Agenda Item #7a O'Reilly Auto Parts Site Plan Review Request

Webb Architects, representing O'Reilly Auto Parts of Springfield, Mo, is requesting site plan approval for their new store proposed for 369 Blue Star Highway. City departments have reviewed the plans and have offered comments as has the zoning administrator. Those comments are included in this agenda and have been forwarded to the applicant. The applicant is working on addressing the comments and will be prepared to discuss those items at the meeting.

PROJECT: NEW O'REILLY AUTO PARTS STORE
 BLUE STAR HIGHWAY
 SOUTH HAVEN, MICHIGAN
COVER SHEET

SHEET
ALTA/ACSM Land Title /
Topographic / Tree Survey

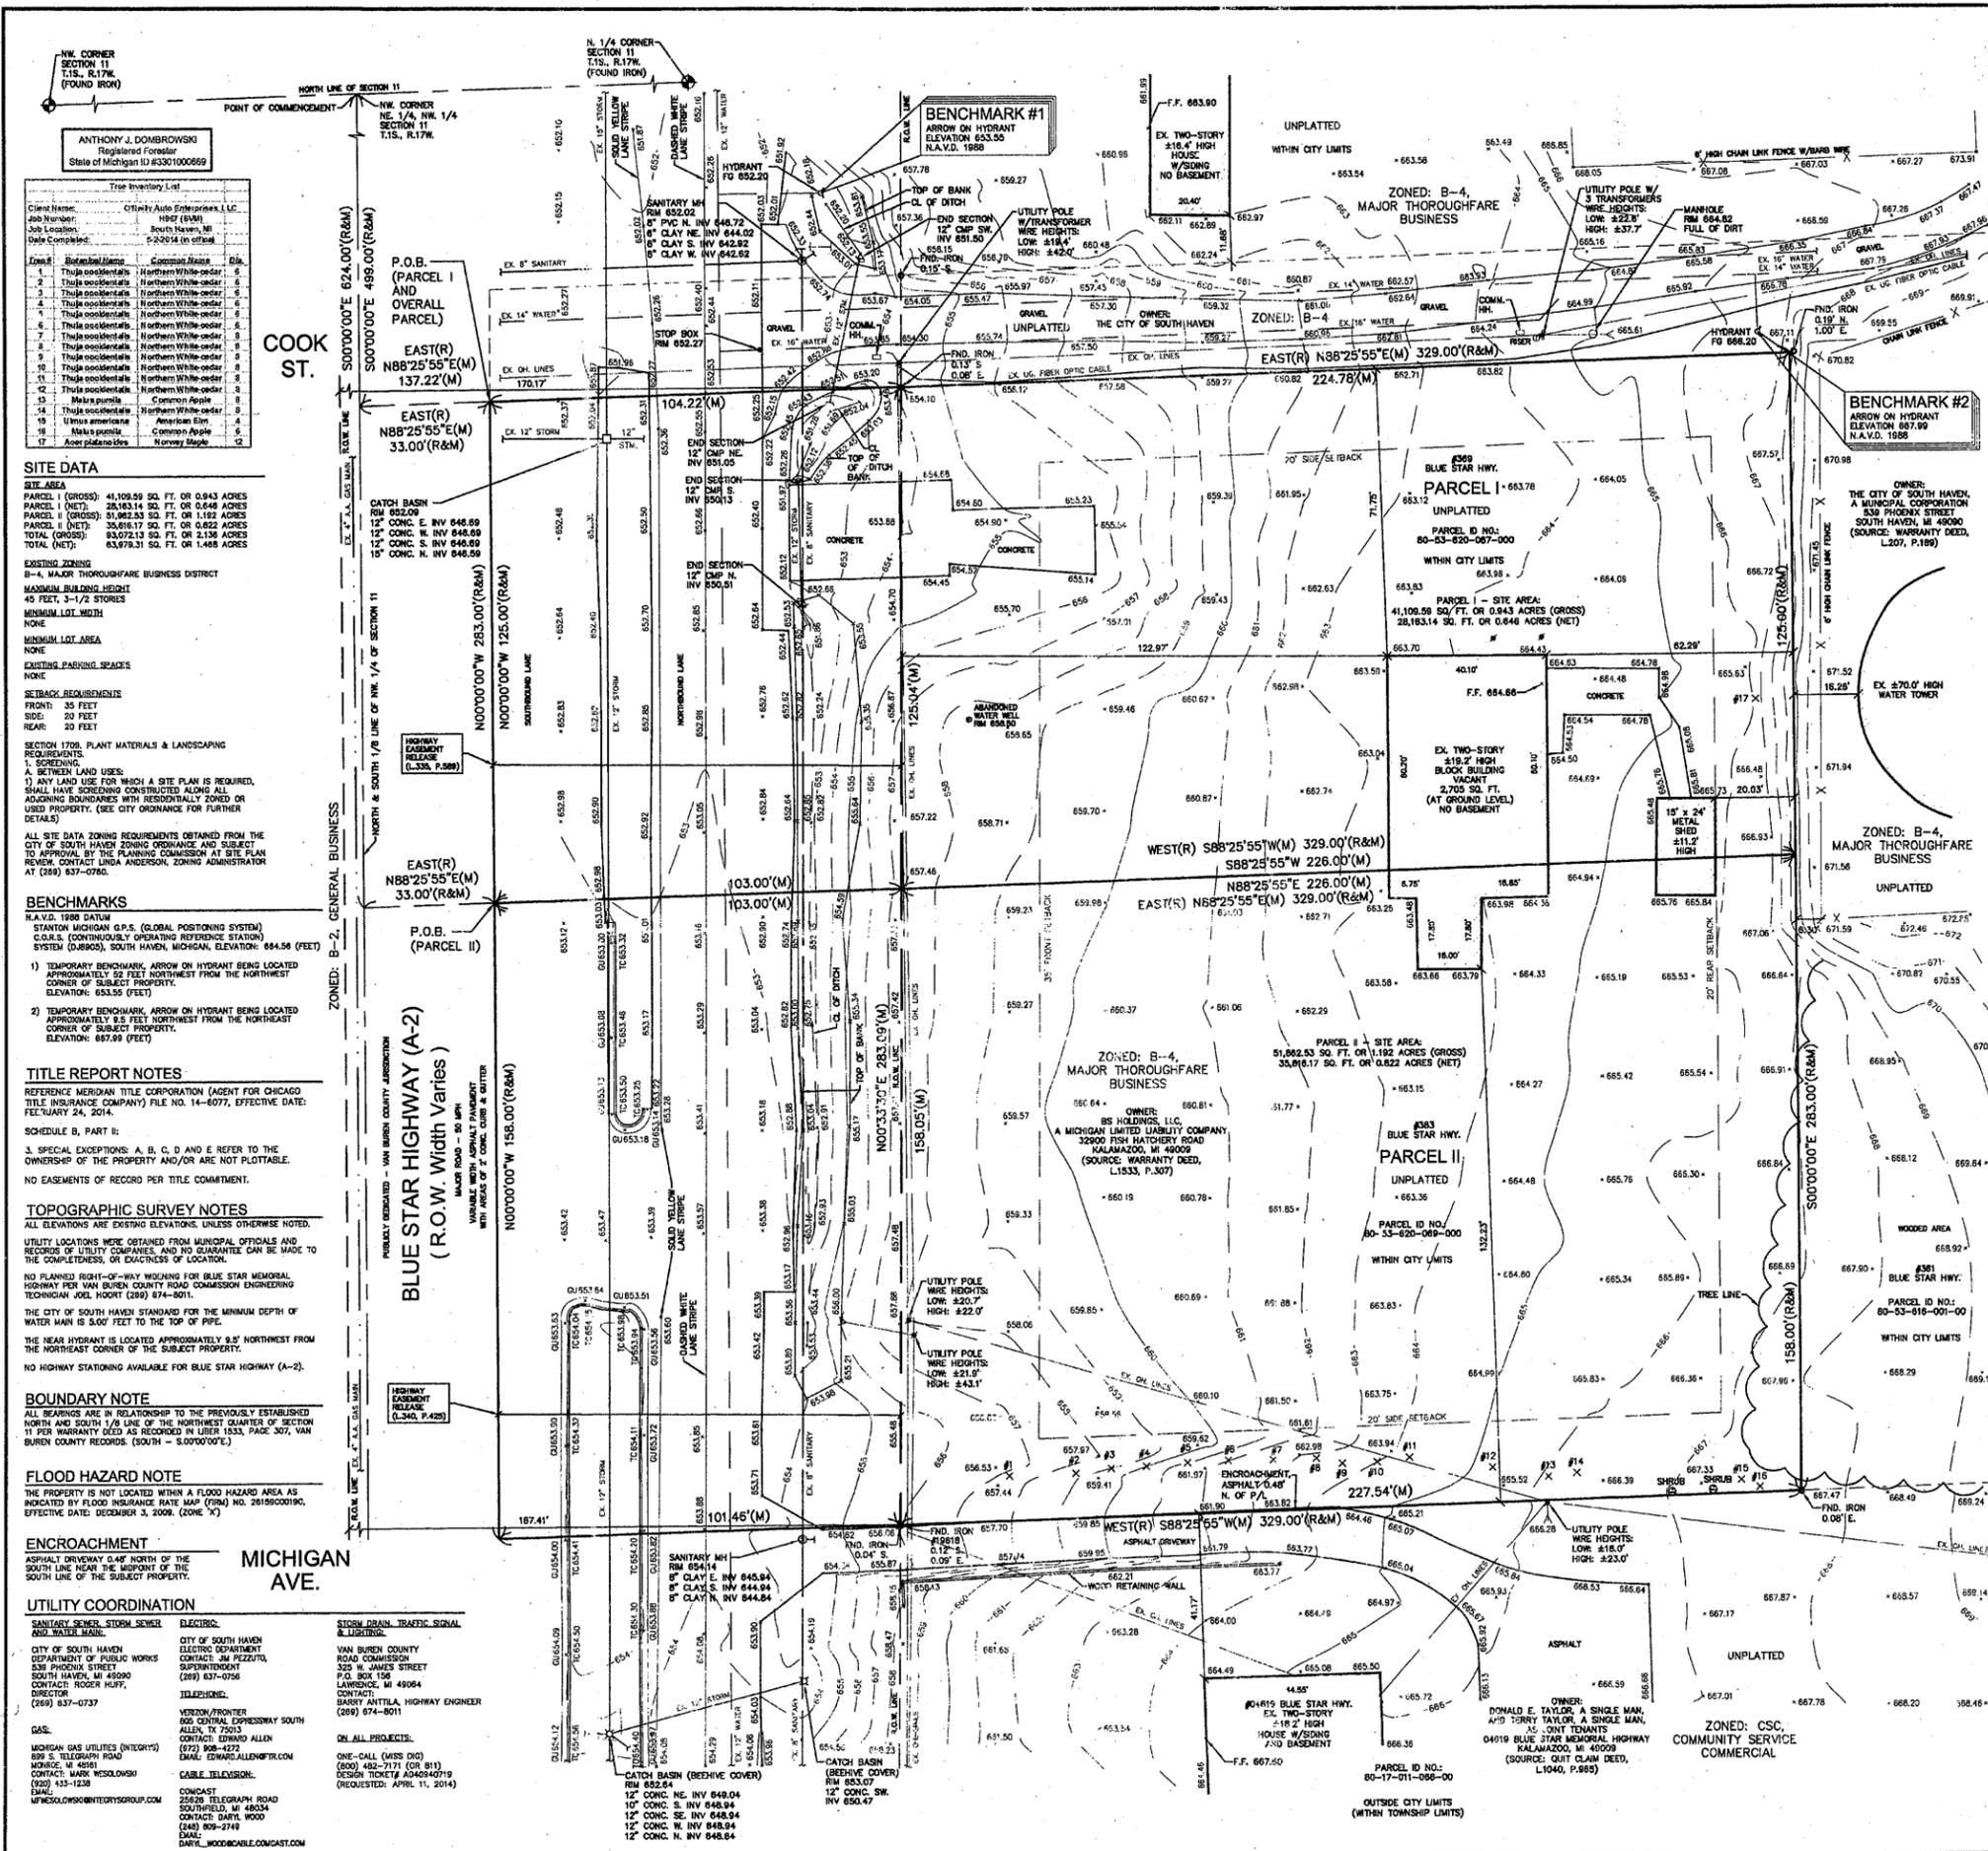
1. The setback requirements on sheet SV1 are incorrect for the overlay zone (setbacks on plan drawing are correct)
2. A driveway permit is needed from VBCRC (Staff understands this is in progress)

1 SITE GRADING PLAN
 SCALE: 1" = 20'

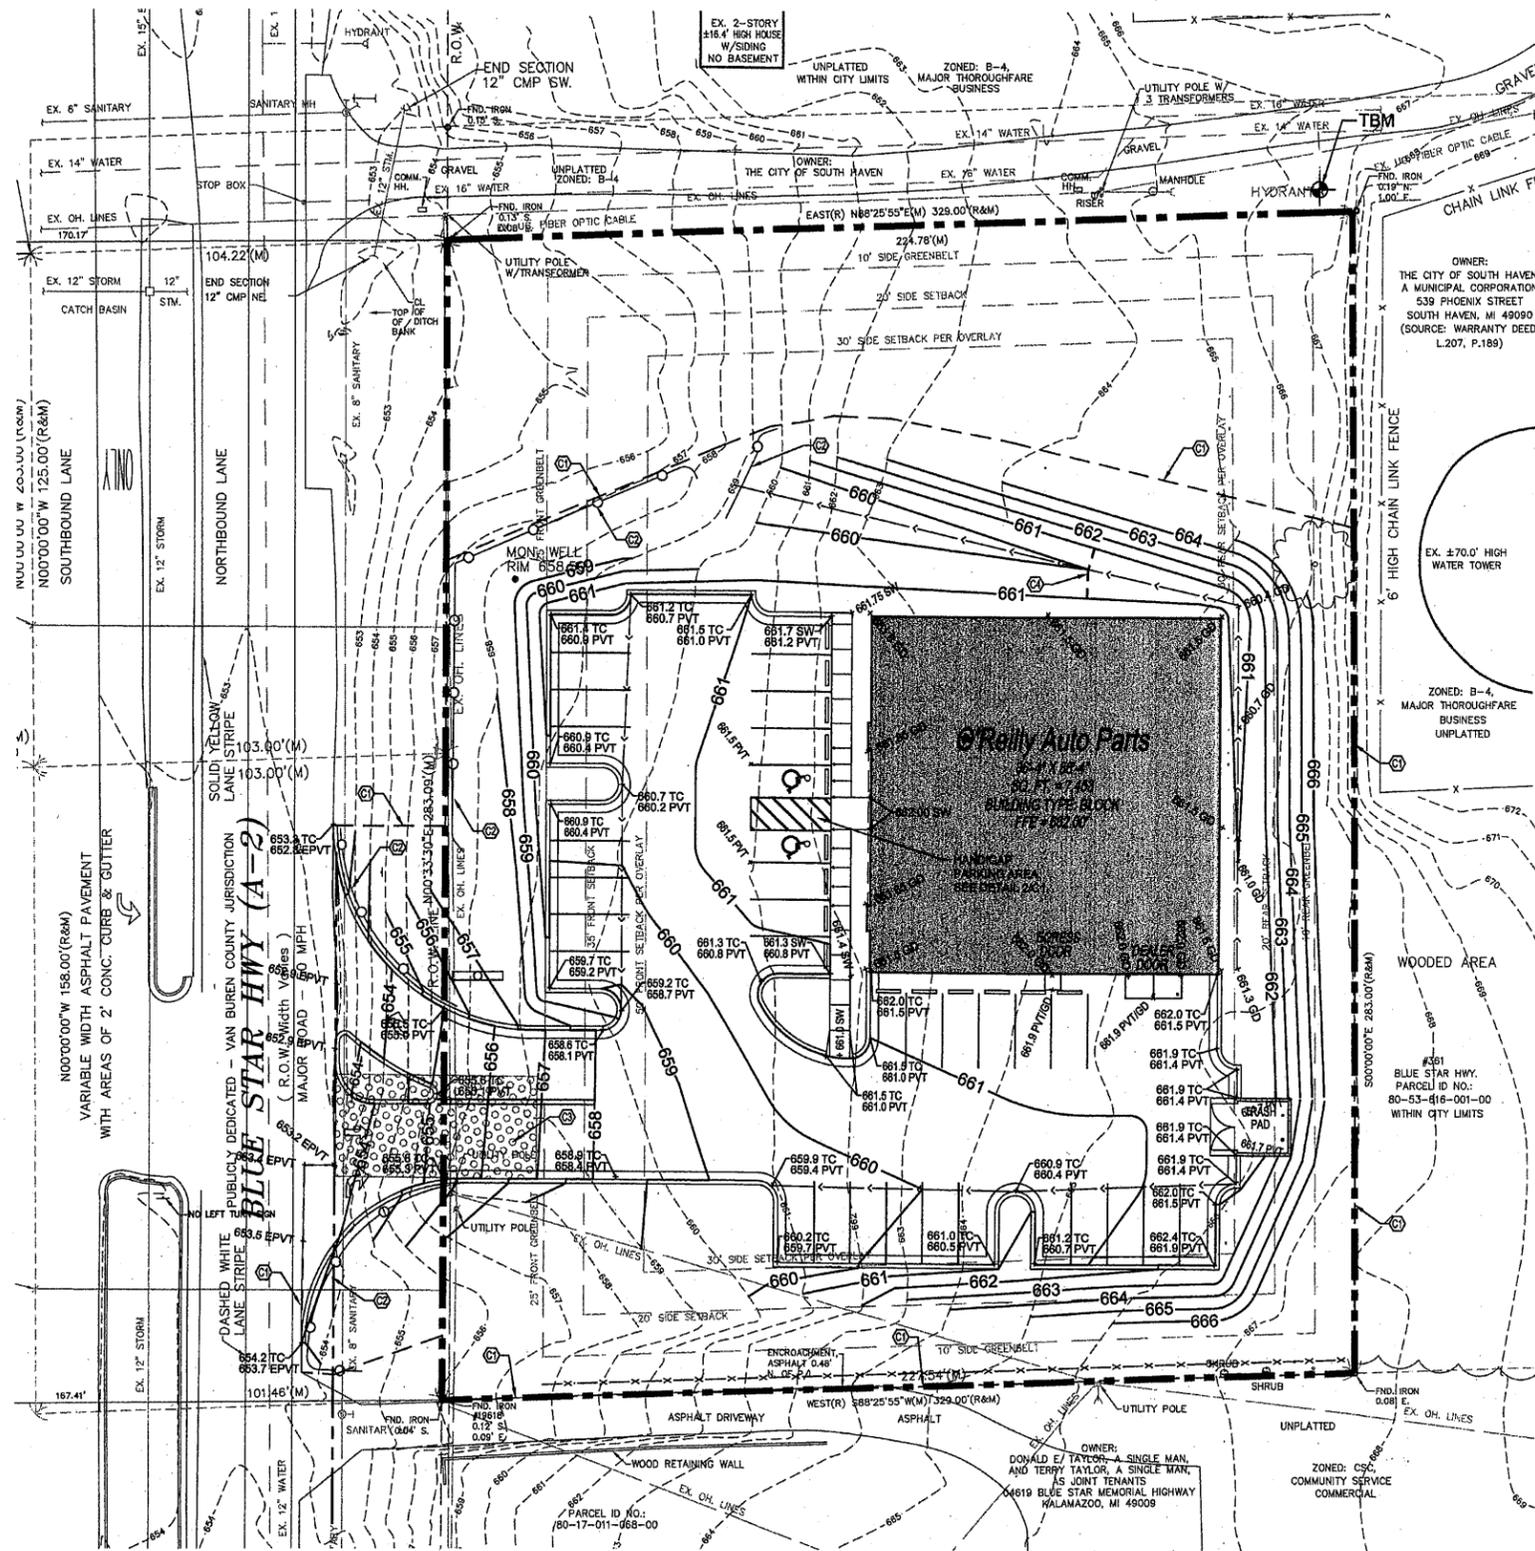
Drawing sheet C1 indicates that storm water runoff will be managed by surface runoff into Blue Star Highway. This method of accommodating storm water runoff is not acceptable. This site must be developed with on-site storm water detention for a 25-year storm event with a release rate not to exceed 0.13 cfs per acre. Appropriate conveyance facilities must be designed to convey runoff to the detention basin. These may consist of storm sewers and catch basins, drainage swales and ditches, or direct surface runoff.

1 SITE DEVELOPMENT PLAN
SCALE: 1" = 20'

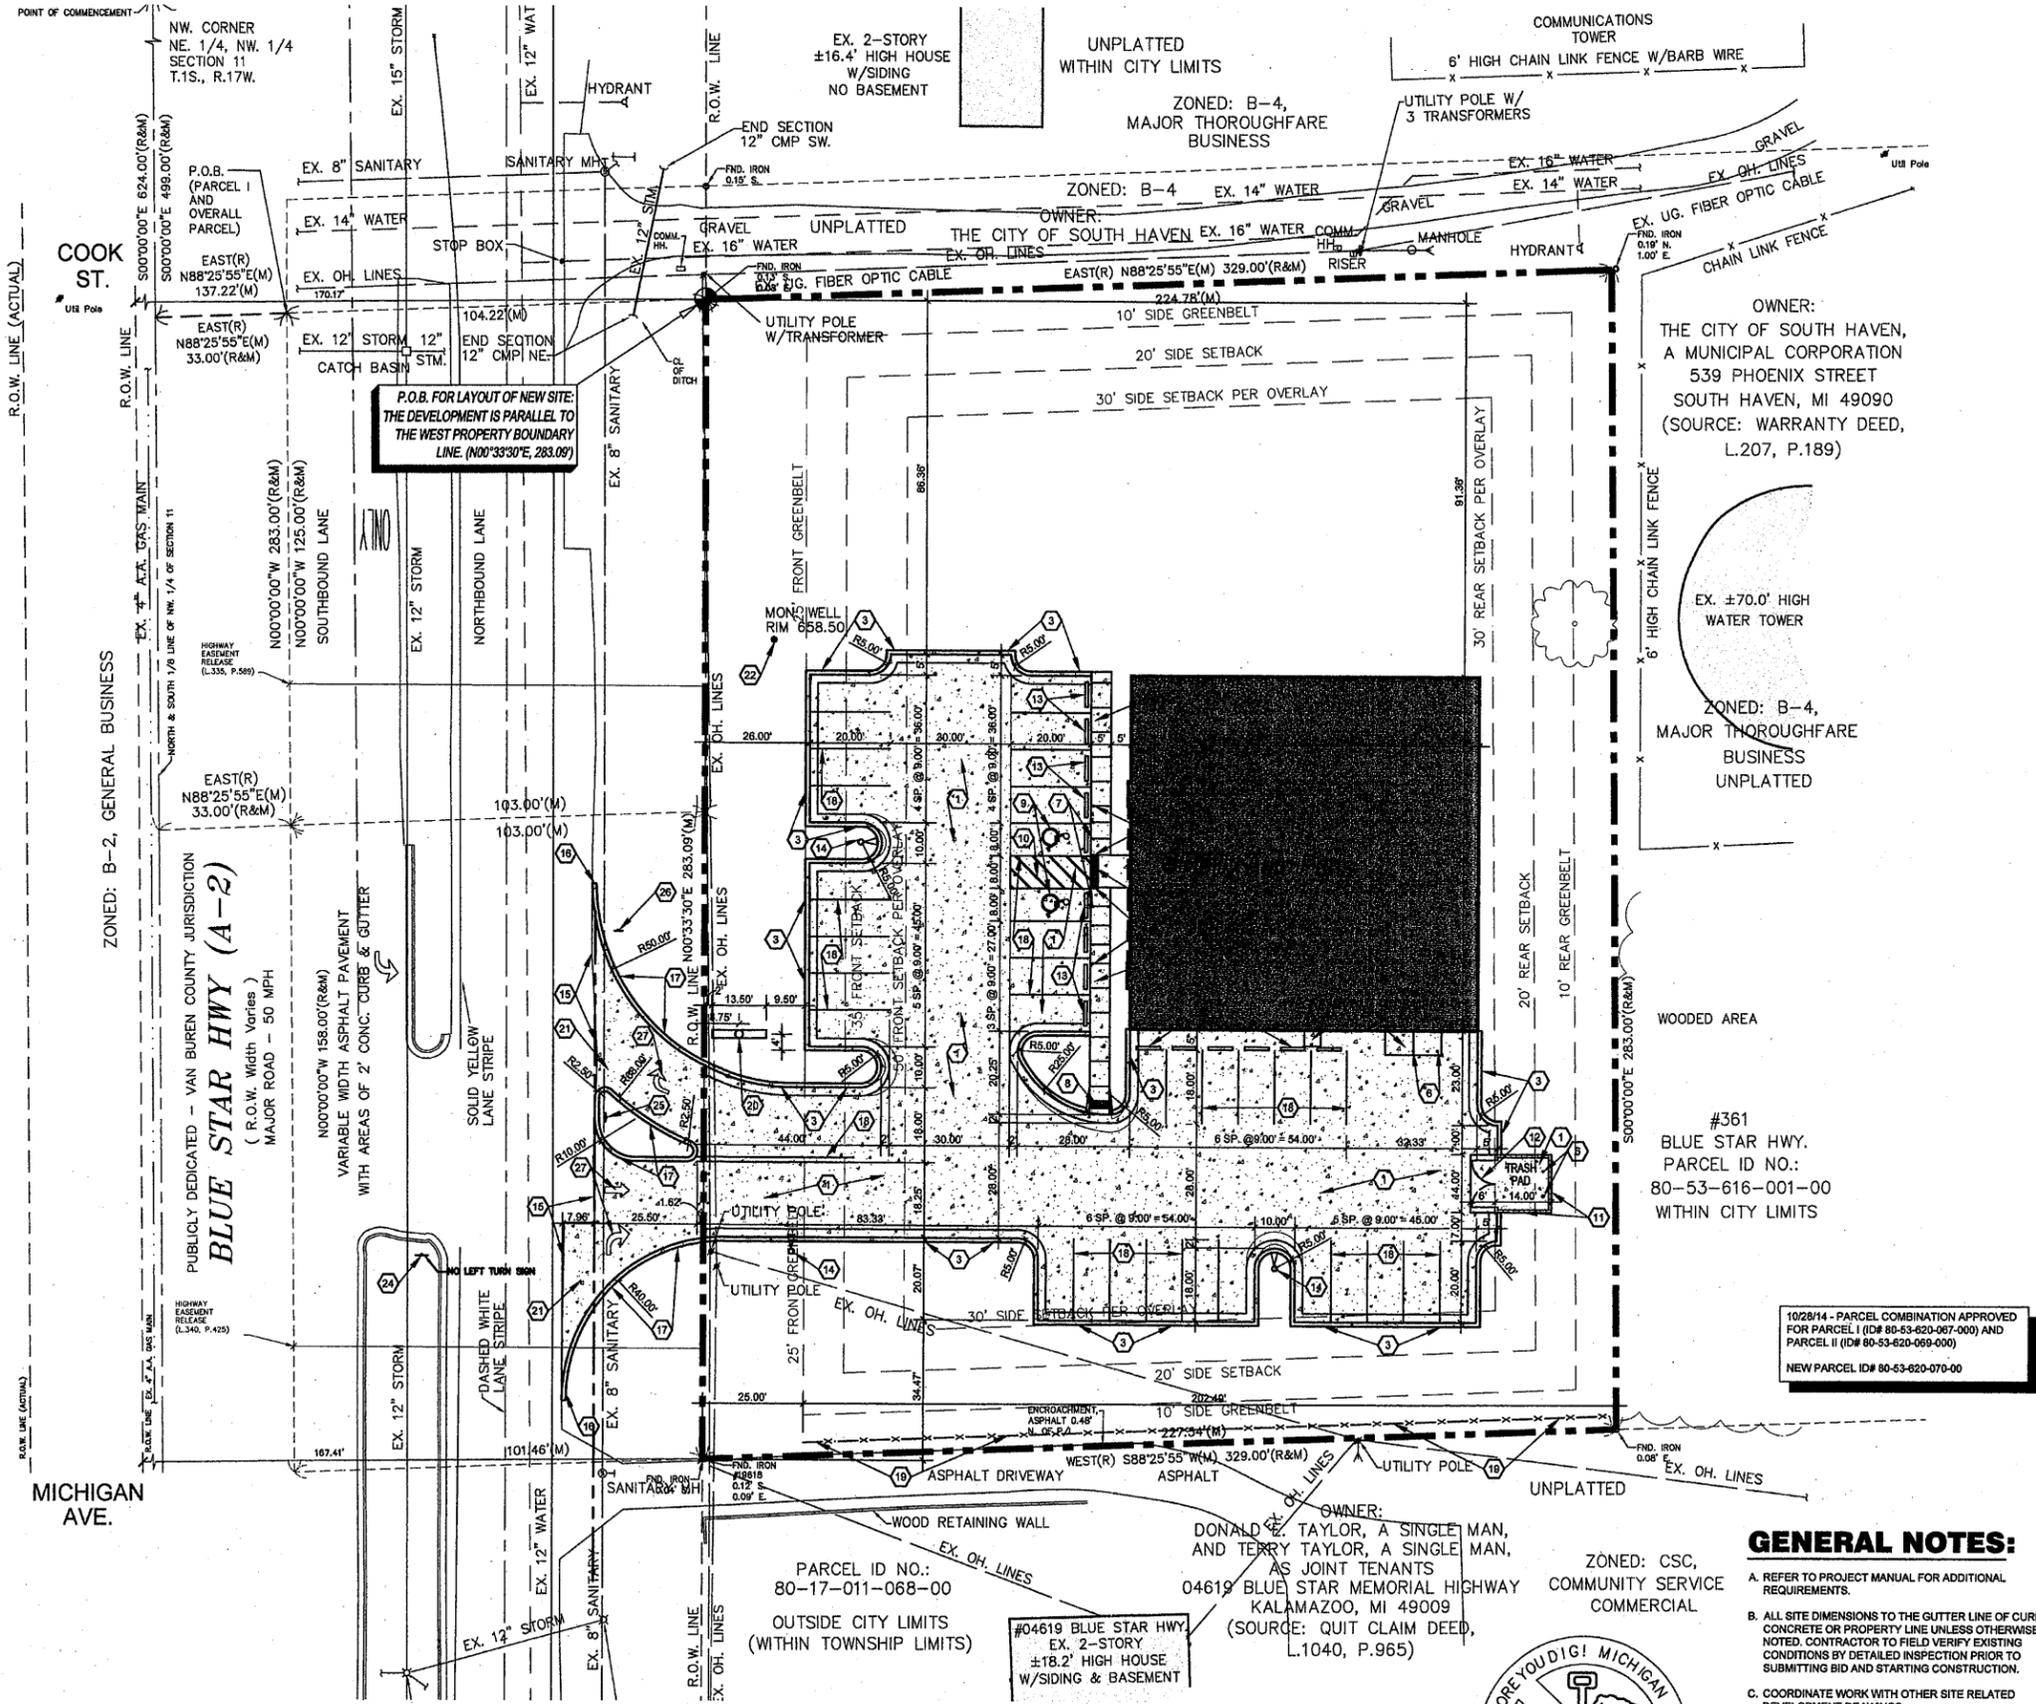
Drawing sheet C2 indicates several lane use arrows at the site entrance driveway. Arrows for entering traffic are not necessary. The right turn arrow for exiting traffic is necessary and should be supplemented with an ONLY legend painted on the pavement. The arrow and ONLY legend should be painted white, not yellow as called out in note 27. In addition to the stop sign, a R3-5(R) sign (right turn only) should be placed at the exit driveway.
